Tuolumne Utilities District

NOTICE TO PLANHOLDERS
ADDENDUM NO.4

PROJECT: Techite Pipeline Replacement Project, Phase II
TO: All Planholders of Record
FROM: Tuolumne Utilities District
BID DATE: April 2, 2021 at 2:00 p.m.
Mandatory Pre-Bid Meeting: March 18, 2021 and/or March 22, 2021

CUT-IN-TEE

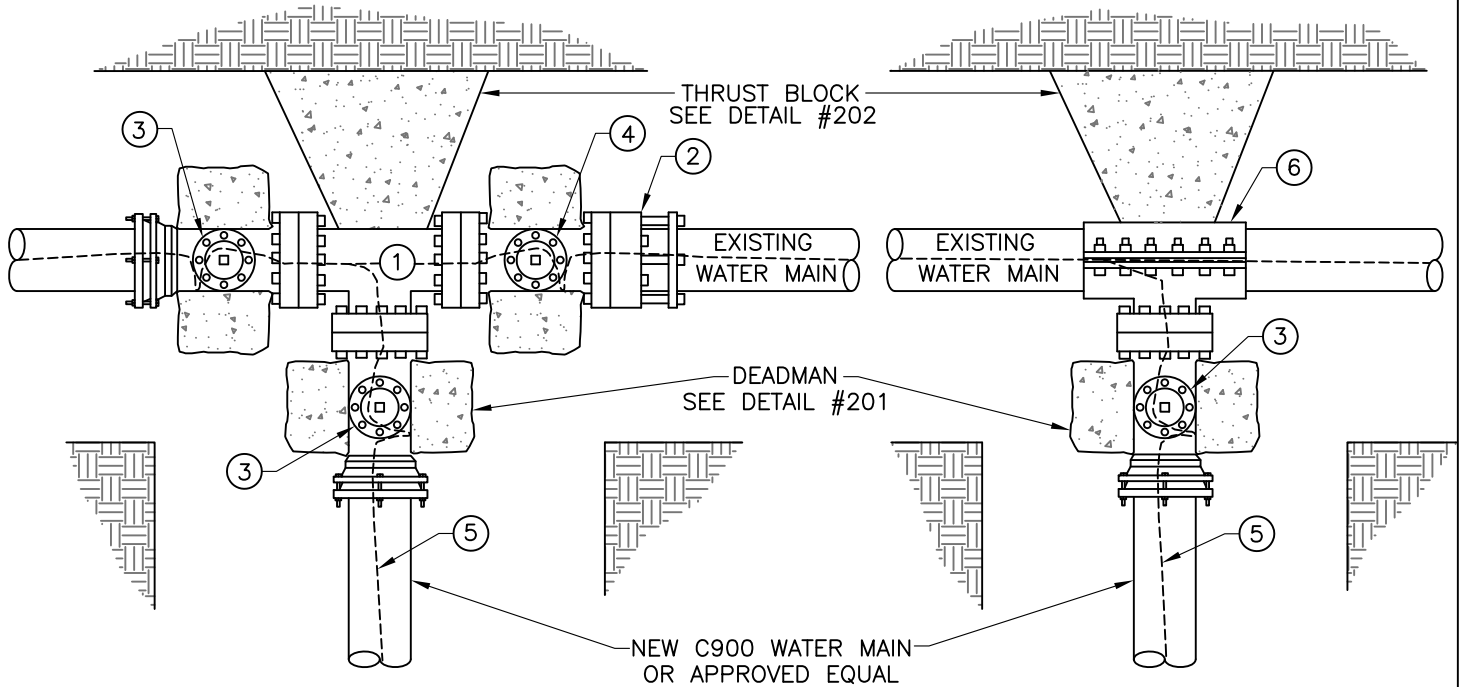
ADDITION: Standard Detail

TUD Standard Detail 209 is attached and is incorporated into the design drawings.
